NORTH LANTAU EXPRESSWAY

**Environmental Assessment Report
Tung Chung Section
Final Report
Agreement No. CE/18/81**

Government of Hong Kong
Highways Department

March 1992

Figure 4.5
Noise Contour Plot on Section A-A

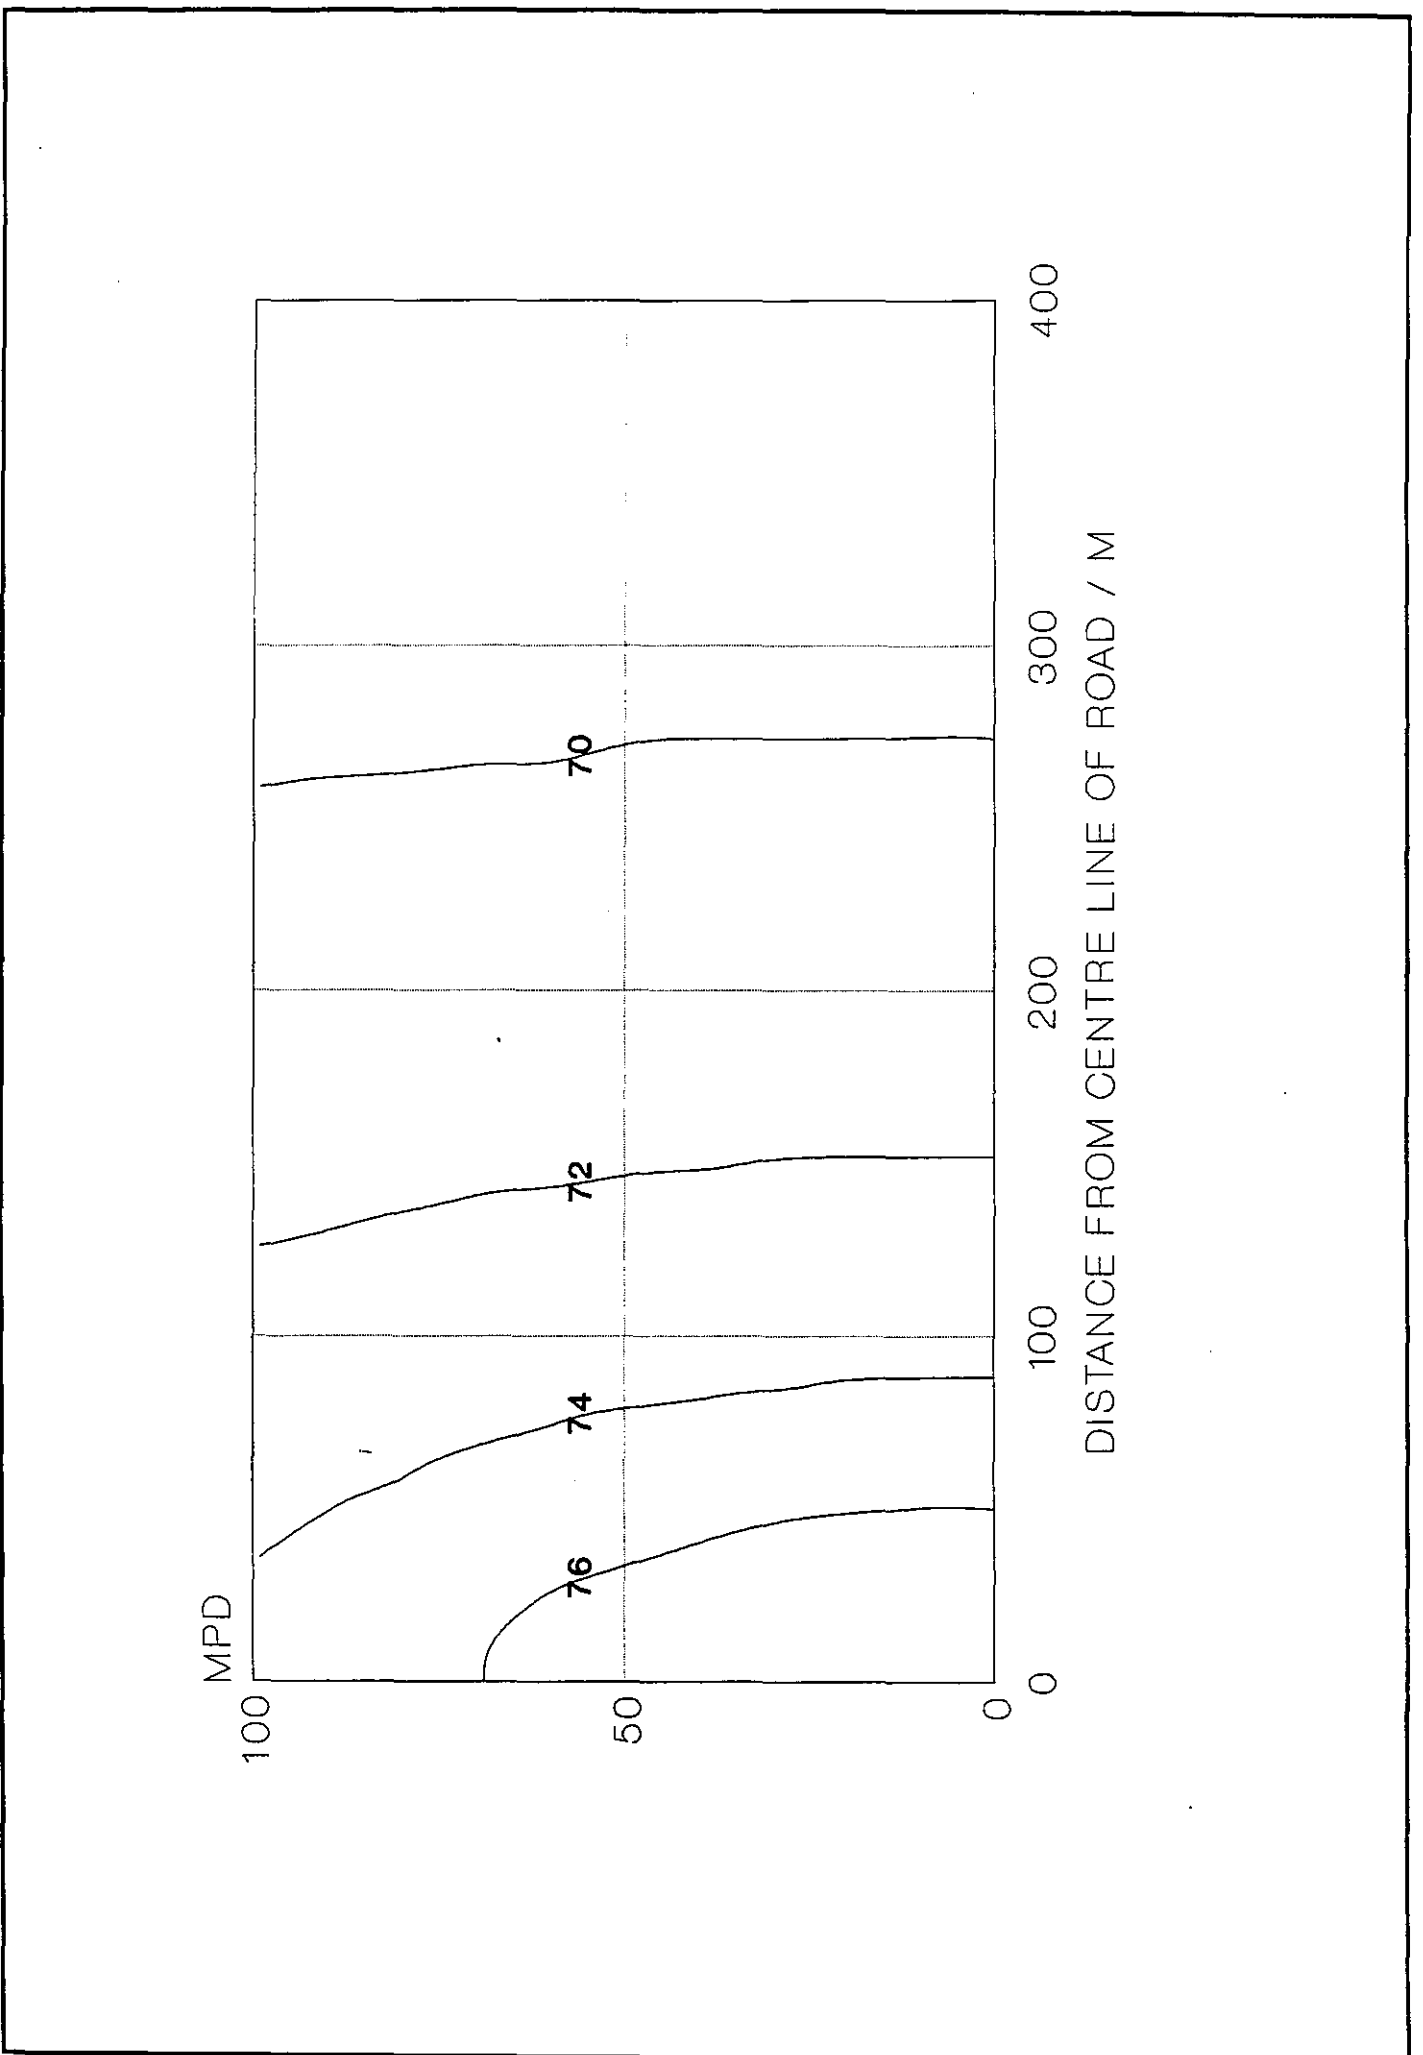
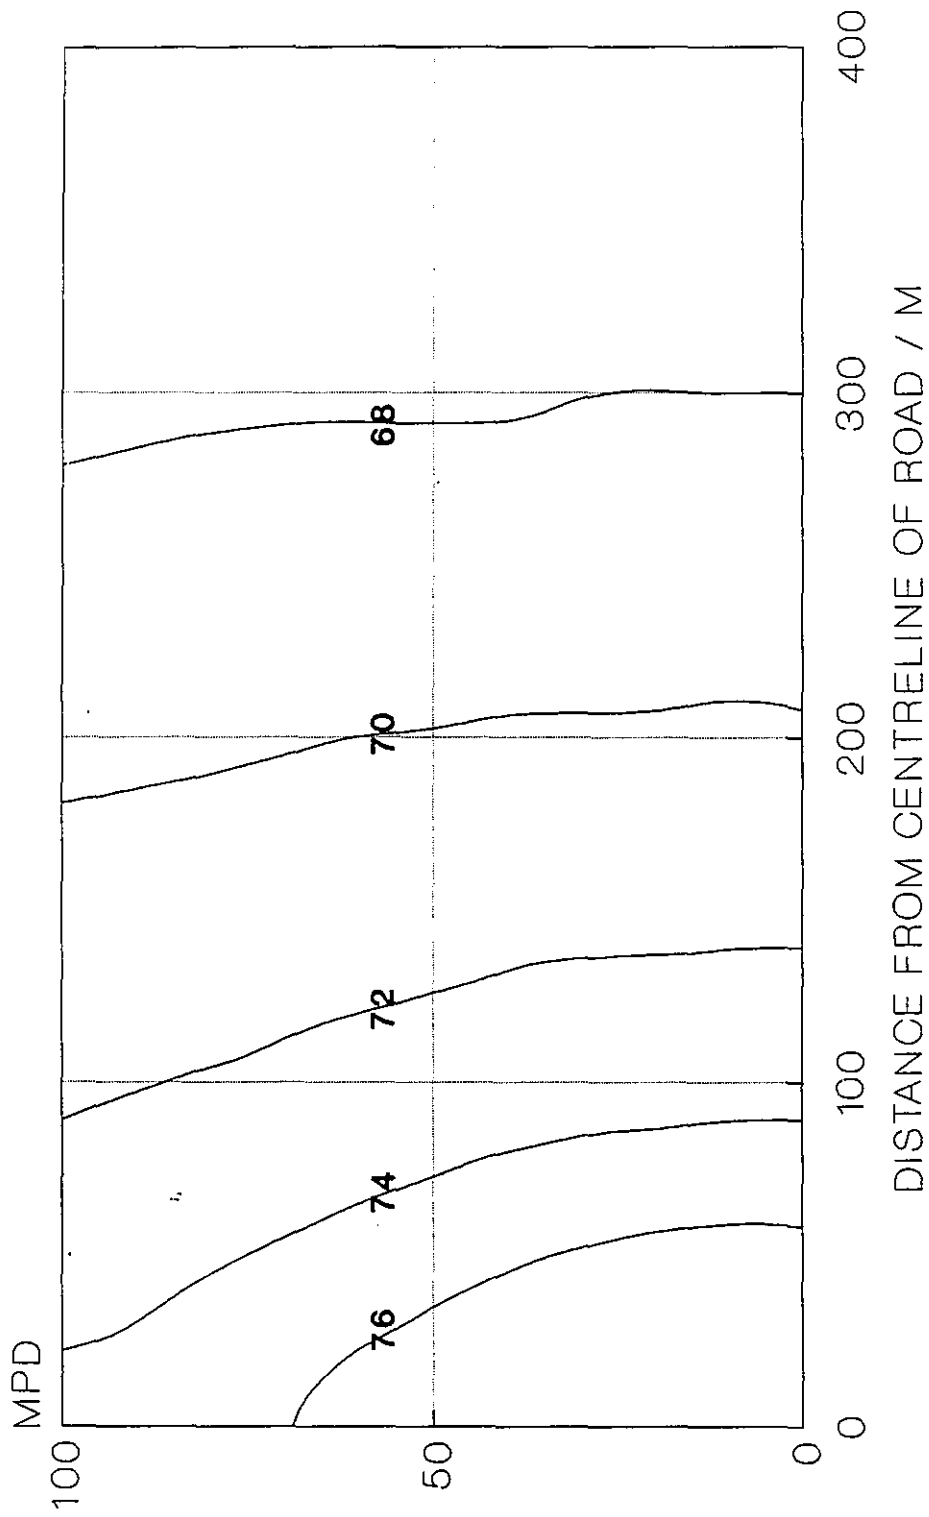
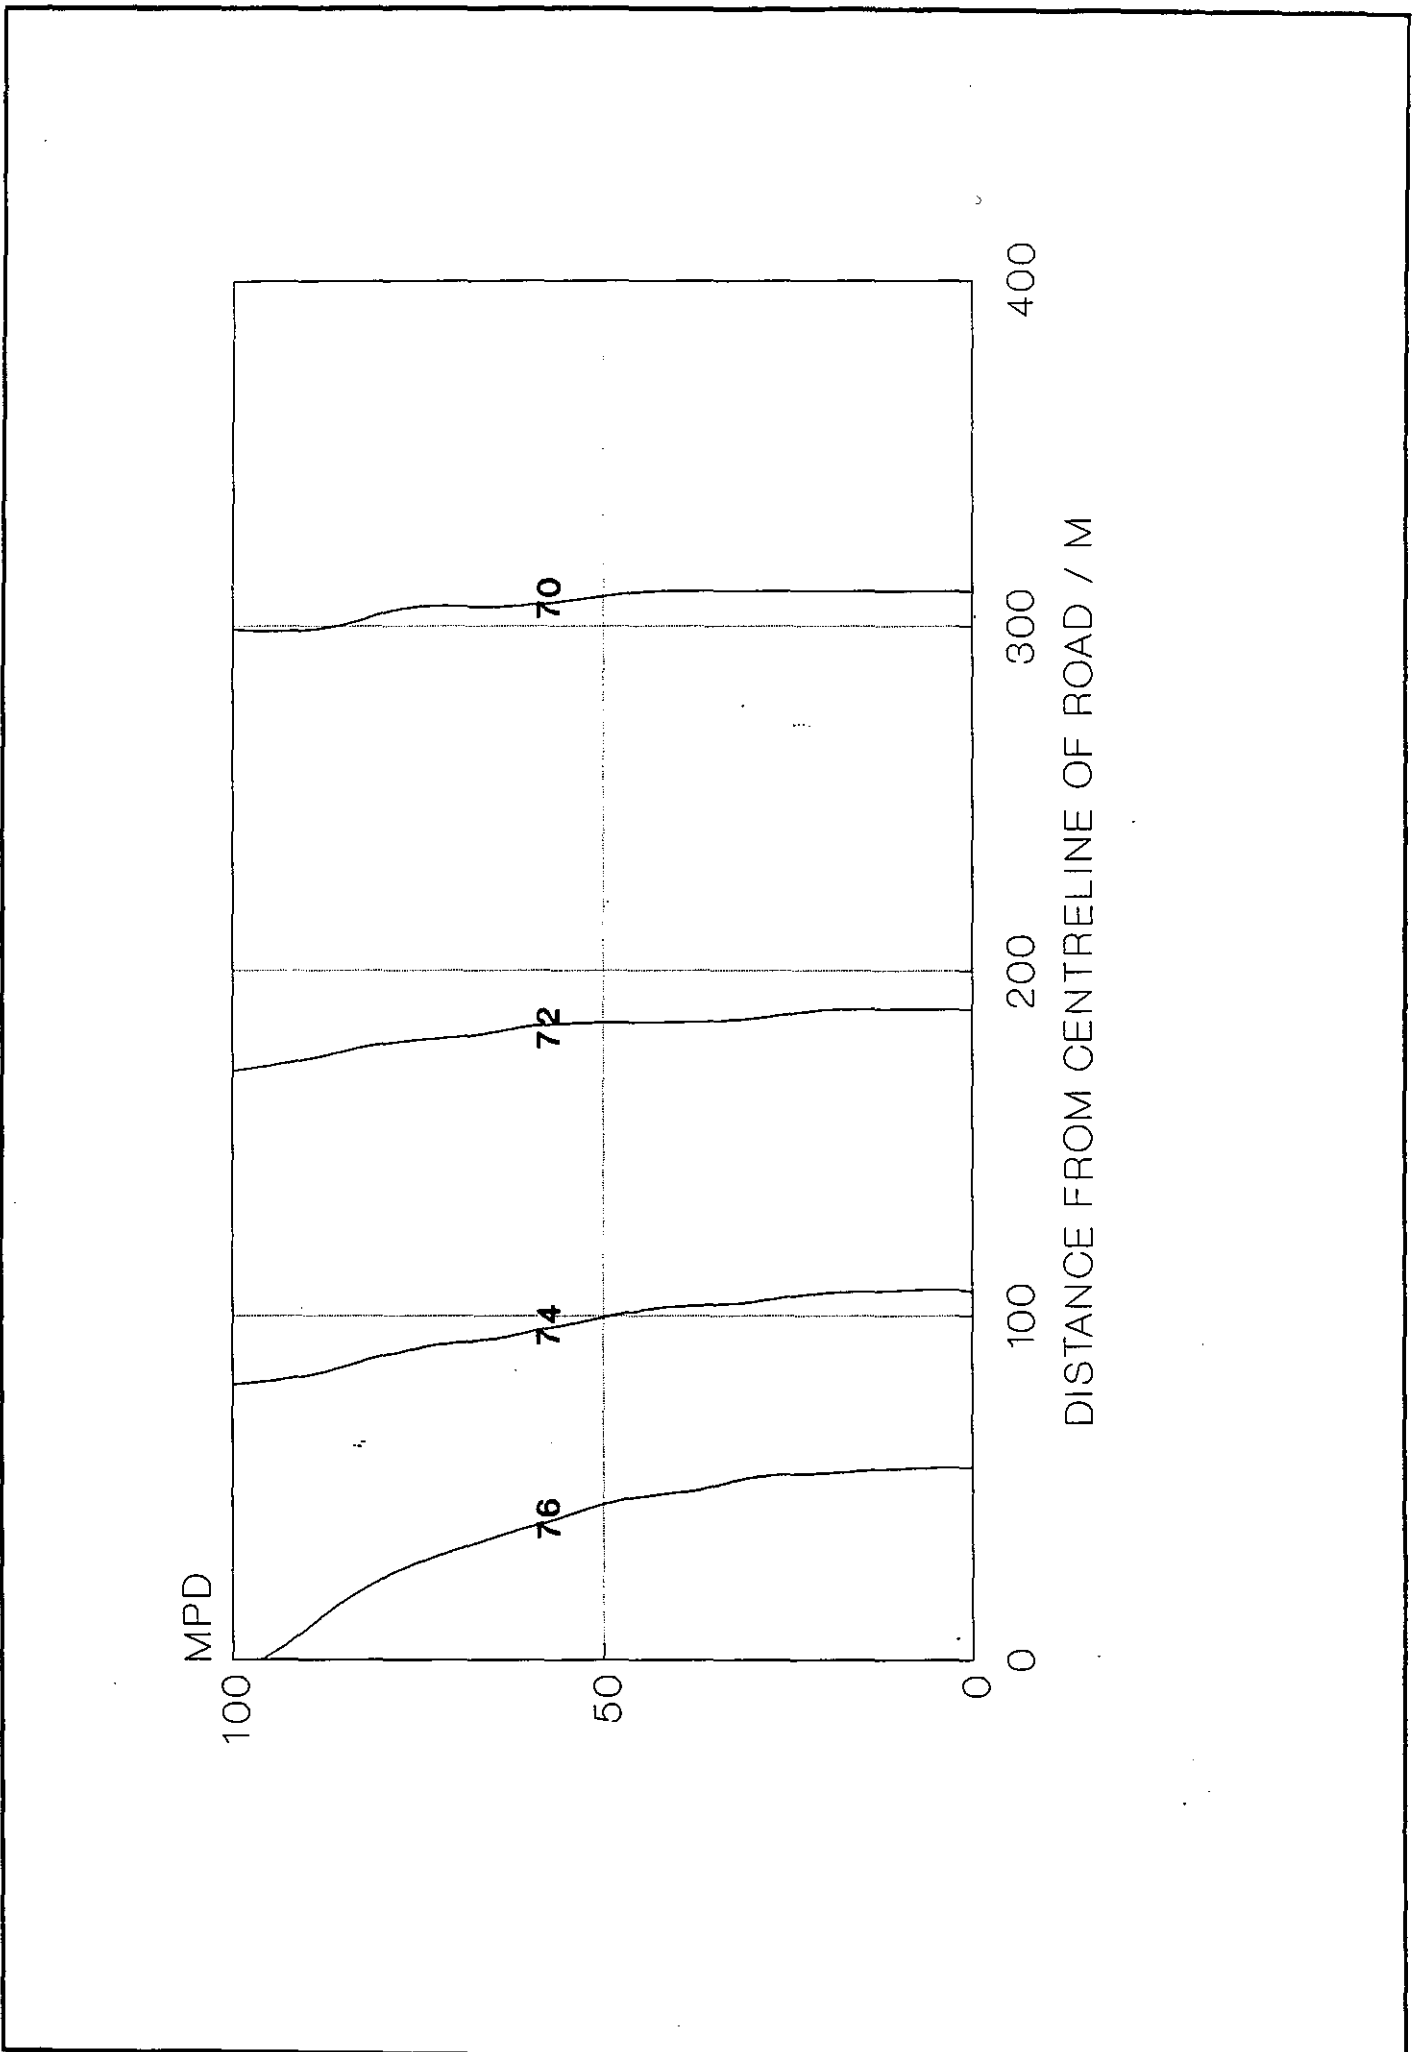
- (v) Figures 4.2-4.4 are based on the draft RODP which has already been superseded by the Interim RODP. For example, the NLE/AR corridor is now elevated across primary distributor P1. Does this change affect the noise contour plots shown on Figures 4.5-4.7?

Figure 4.18
Noise Contour Plot - Earth Mound and Barrier

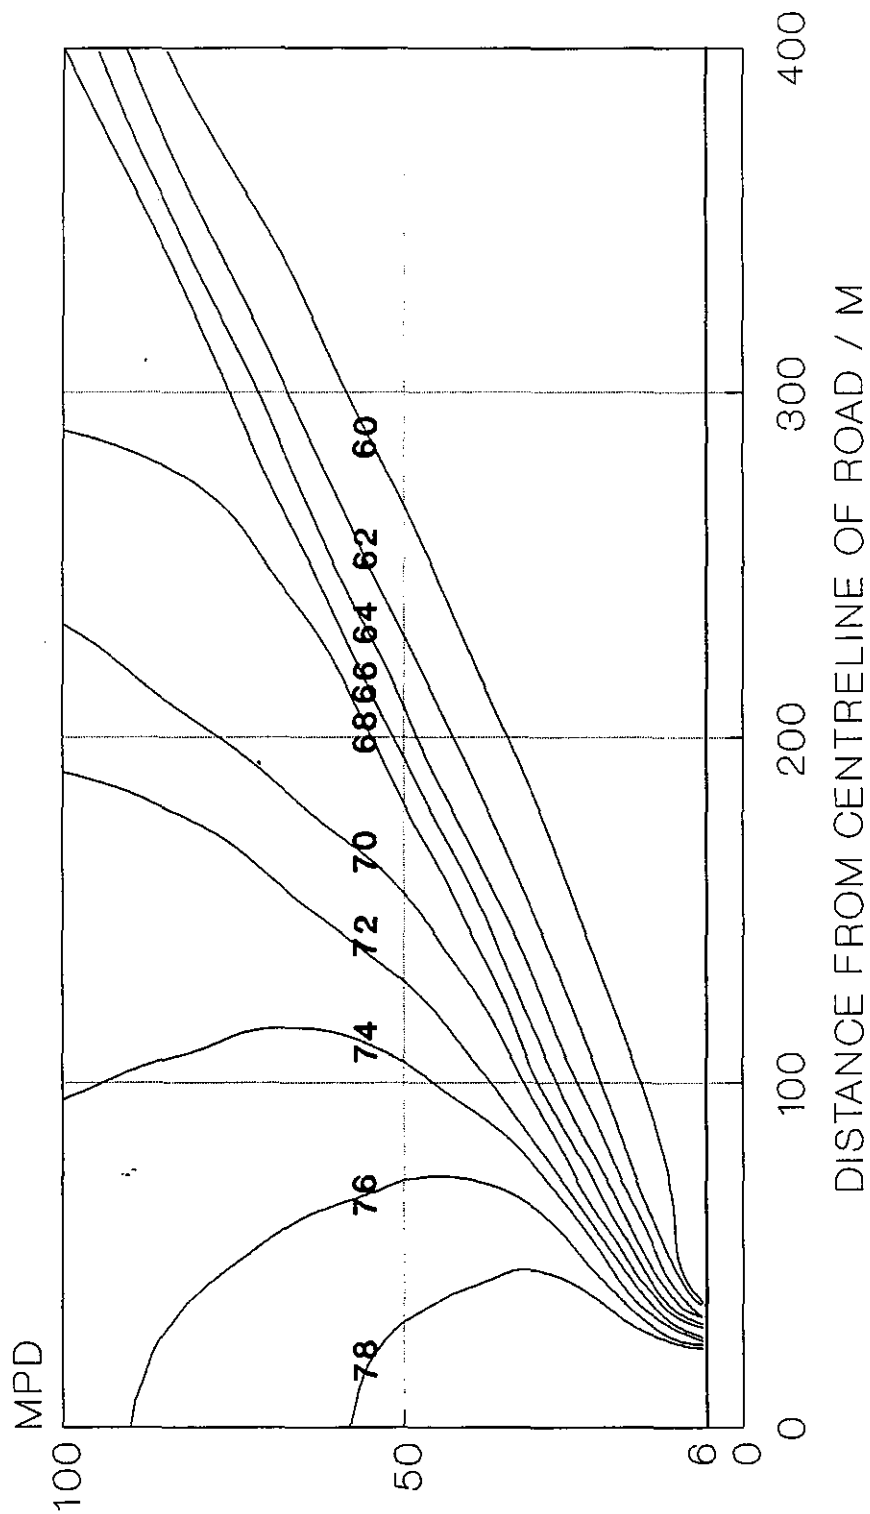
- (i) In deriving the Tung Chung Interim Recommended Outline Development Plan (RODP), the Consultants of North Lantau Development Study have assumed the incorporation of a three meter high noise barrier on top of a six meter earth mound as a mitigation measure along sections of the Expressway running through residential developments. Fig. 4.3 has only indicated the $L_{10(1-hr)}$ contour overlay on the RODP at no mitigation measure situation. I suggest that another plan indicating the "with mitigation measure (ie earth mound and barrier)" situation should be inserted. This office is particularly concerned whether the planned low rise G/IC buildings in Area 12 (ie schools) would be adequately screened from the road traffic noise after the incorporation of the proposed noise barriers along the Expressway. Based on the Noise Contour Plot of Earth Mound & Barrier situation (Fig. 4.18), it seems that the G/IC buildings (assume 30m +mPD) in these two areas would require a buffer distance of about 110m from the centre line of the Expressway such that nearly half of the Area 12 would not satisfy the 65 dB(A) standard requirement for schools. The Consultants are requested to clarify the situation and, if necessary, to liaise with the Consultants of North Lantau Development Study on this aspect.

Please see response to comments Pg. 3 (xi) and Pg. 4 (xiii). Fig. 4.18 is applicable where a receiver has 180 degrees angle of view of the road. In practice, however, substantial screening of the sensitive areas, for example, by building orientation or insertion of barrier blocks in between, reduces the noise exposure.
